STATE OF DELAWARE
DEPARTMENT OF TRANSPORTATION
PO BOX 778
DOVER, DELAWARE 19903

Contract No. T200911303.01
Federal Aid Project No. NH-2015(23)
US 301, Levels Road to Summit Bridge Rd.
New Castle County

Enclosed is Addendum No. 1 for the referenced contract consisting of the following:

1-468 DT-2
SHEET NO.
303
TOTAL SHTS.
1256

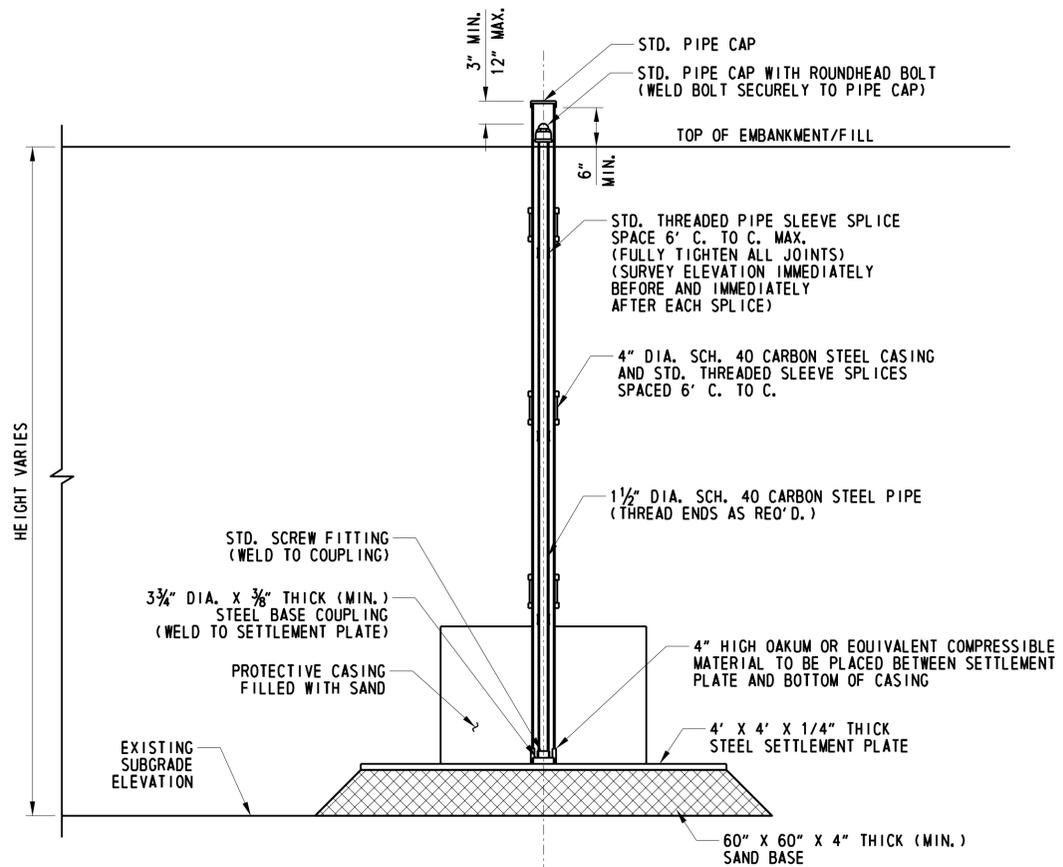
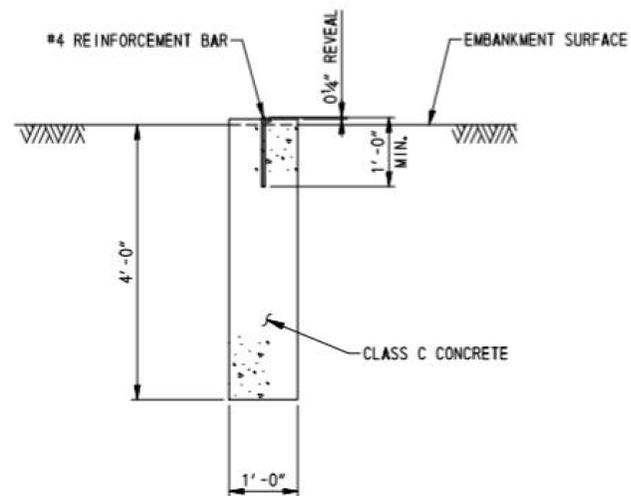
ADDENDUMS / REVISIONS
▲ ADDED DETAIL, DRB

1-472 DT-1
SHEET NO.
389
TOTAL SHTS.
1256

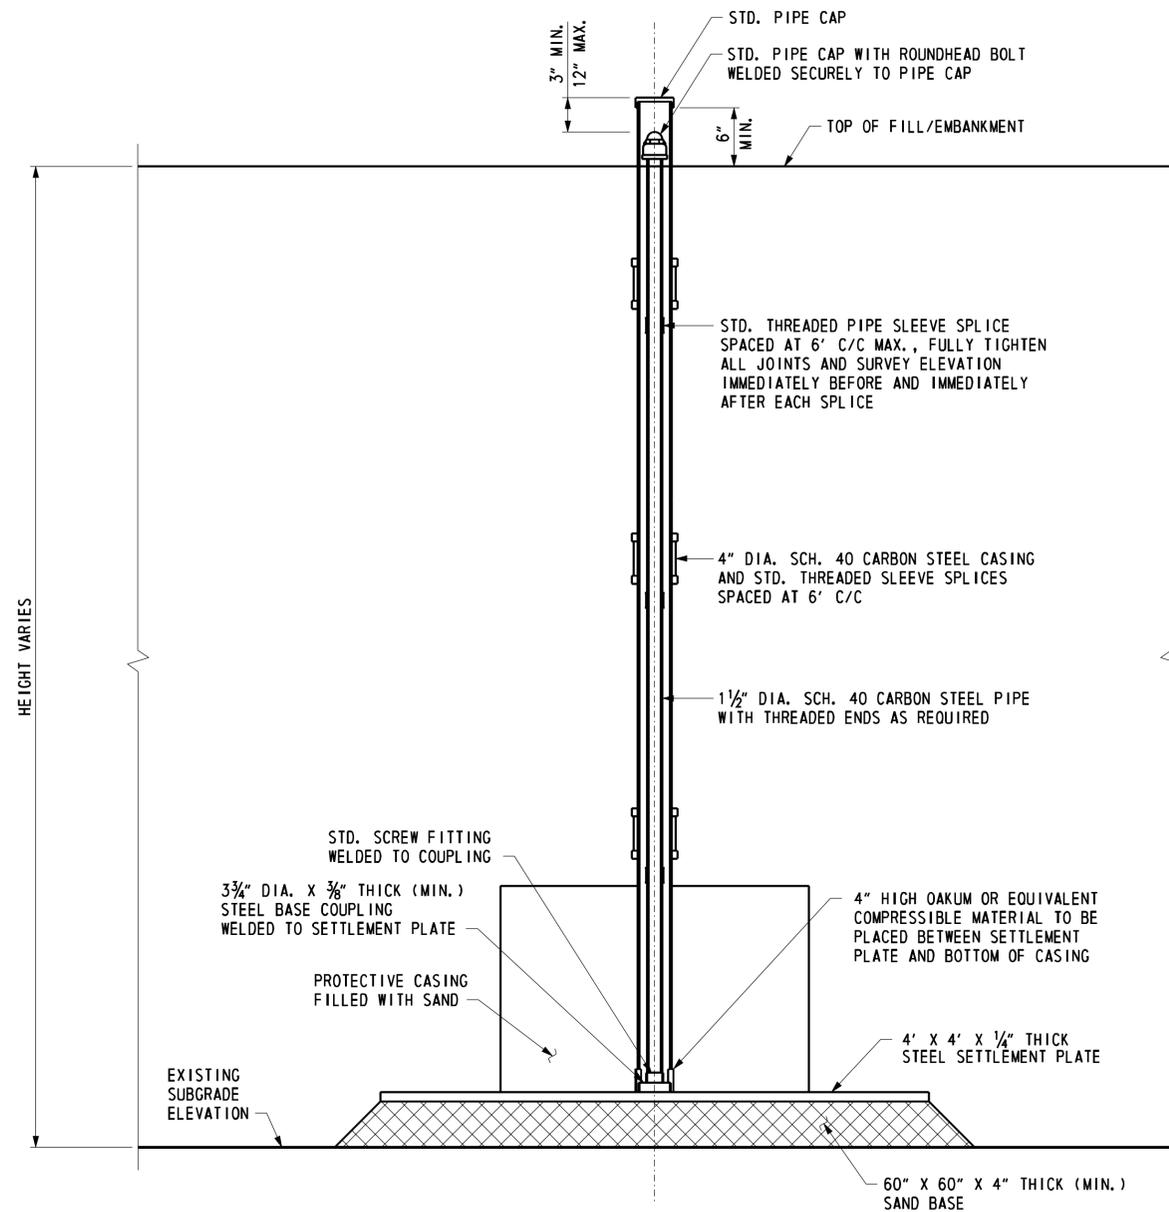
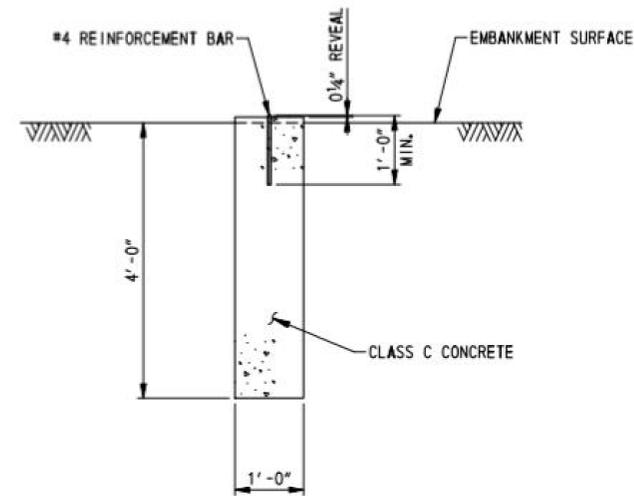
ADDENDUMS / REVISIONS
△ ADDED DETAIL, DRB

1-475 DT-1
SHEET NO.
439
TOTAL SHTS.
1256

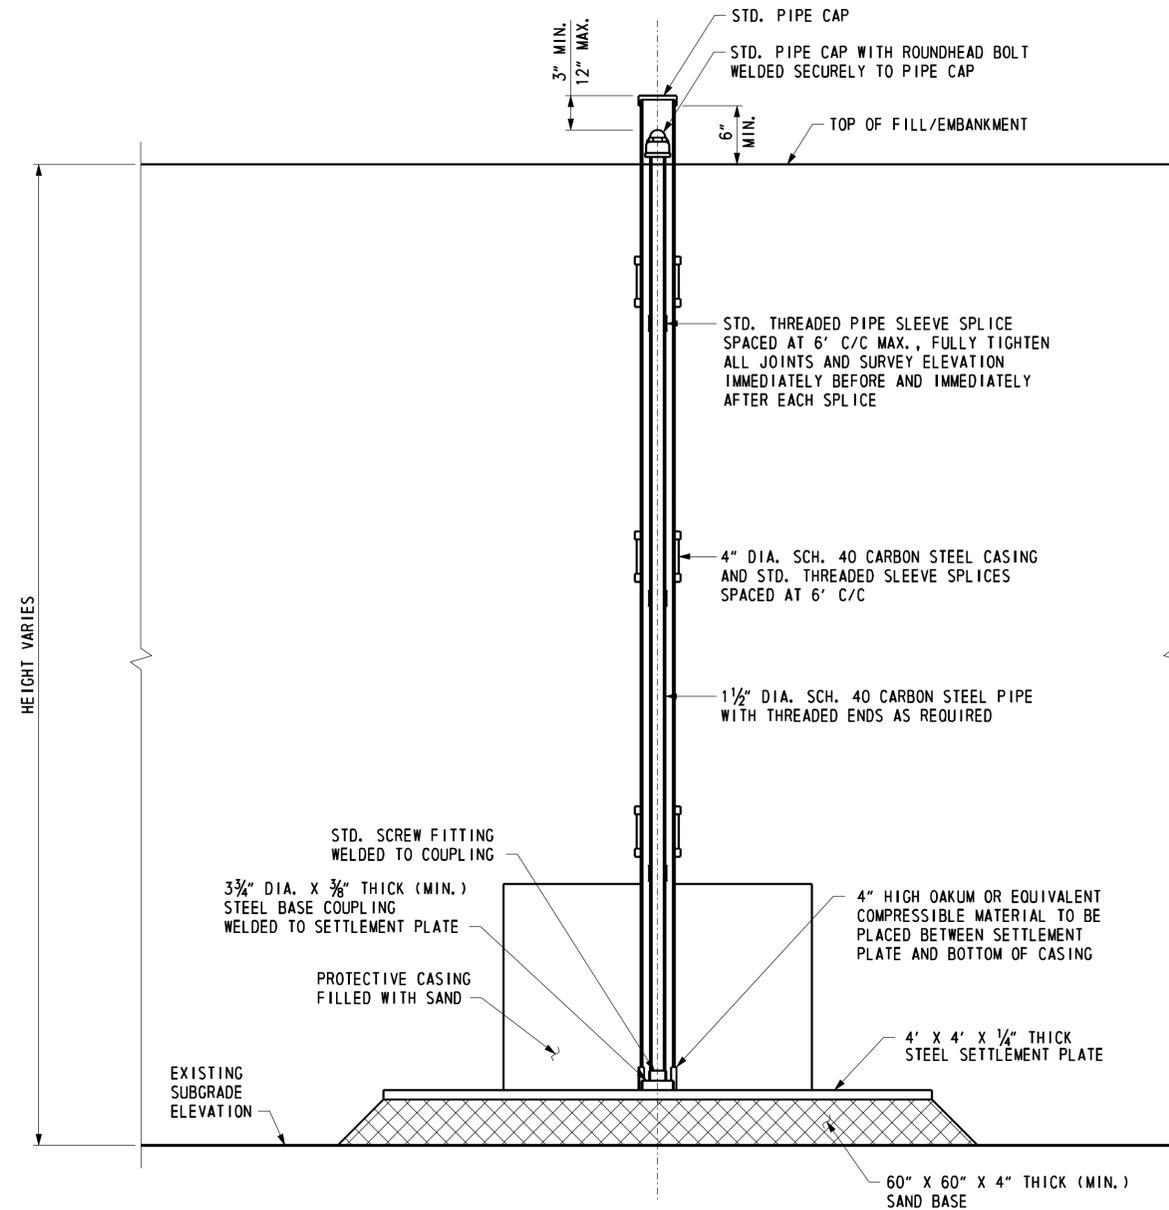
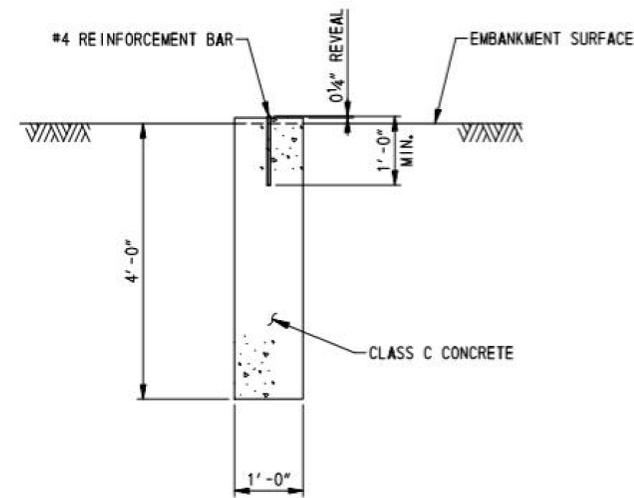
ADDENDUMS / REVISIONS
△ ADDED DETAIL, DRB

1-480 DT-1	
SHEET NO.	630
TOTAL SHTS.	1256

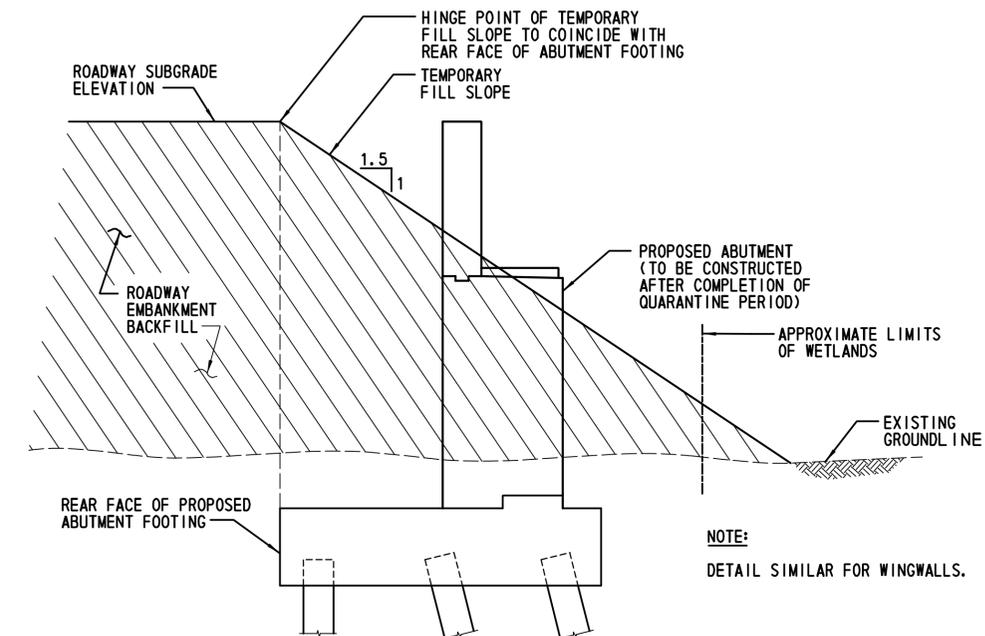
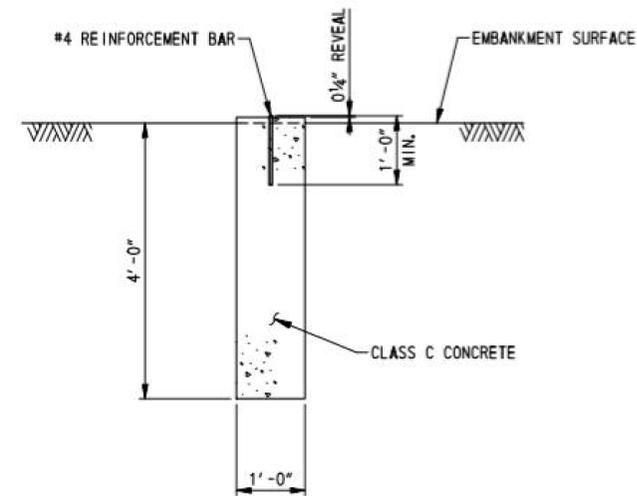
ADDENDUMS / REVISIONS
ADDDED DETAIL, DRB

1-507 DT-2
SHEET NO.
665
TOTAL SHTS.
1256

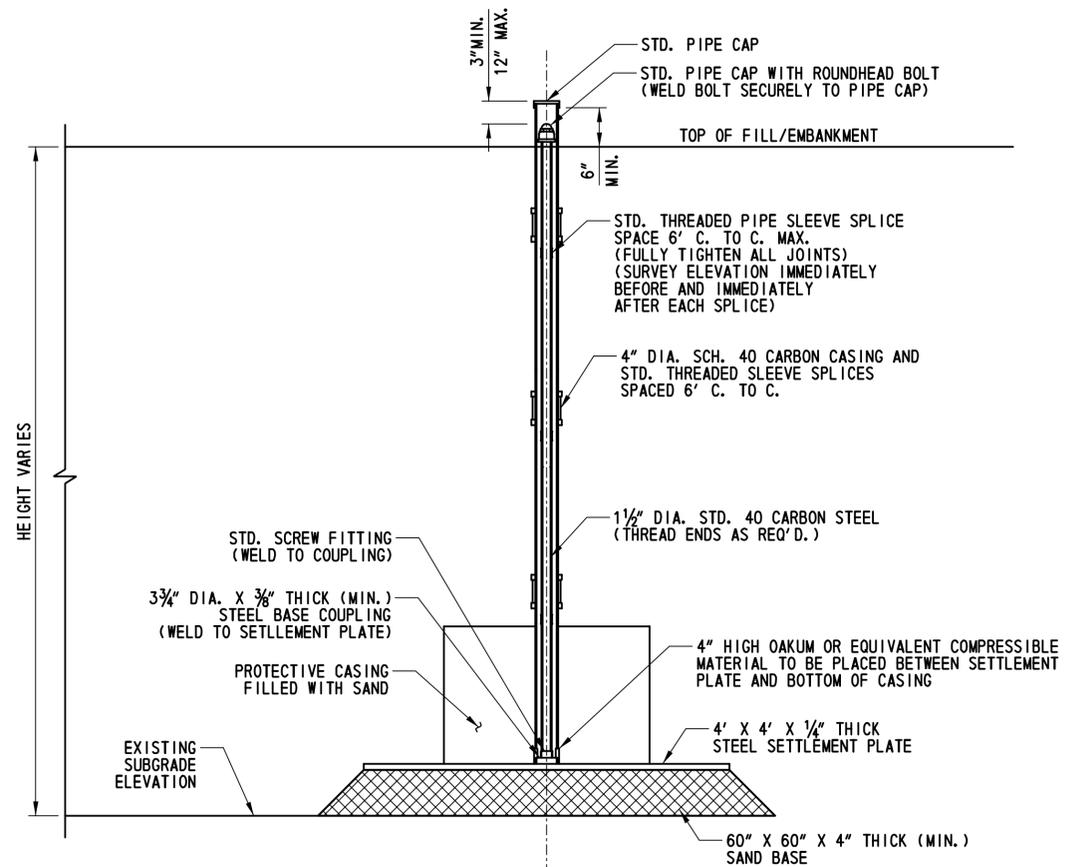
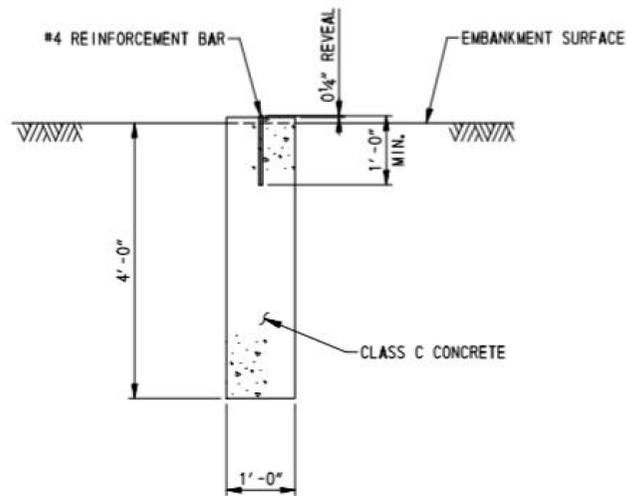
ADDENDUMS / REVISIONS
△ ADDED DETAIL, DRB
